Bulletin No.: PI0927

Service Bulletin

Subject: Squeak/Creak Type Noise from Driver and/or Passenger Seat Track Front Mounting Area

Models: 2010-2013 Chevrolet Camaro
Built Prior to November 7, 2012

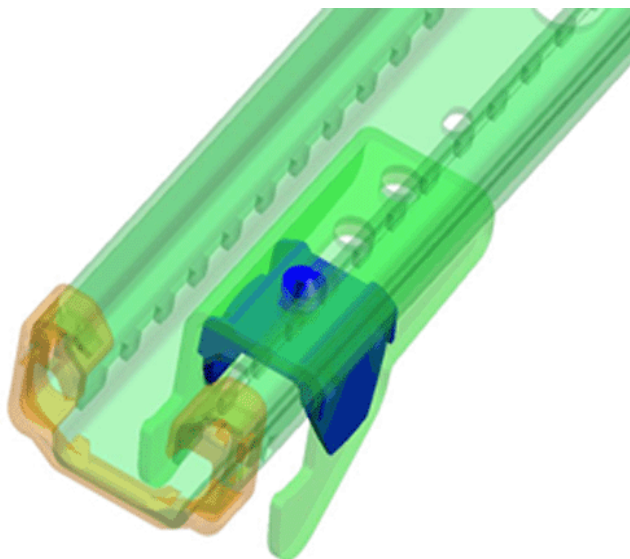
Some customers may comment on a squeak/creak type noise from the driver and/or passenger seat track front mounting area.

This may be caused by the seat front hooks not centered in the floor/body slots, making a metal squeak/creak noise.

Install a spacer between the front seat track hooks for the driver and passenger seats following the procedure below.
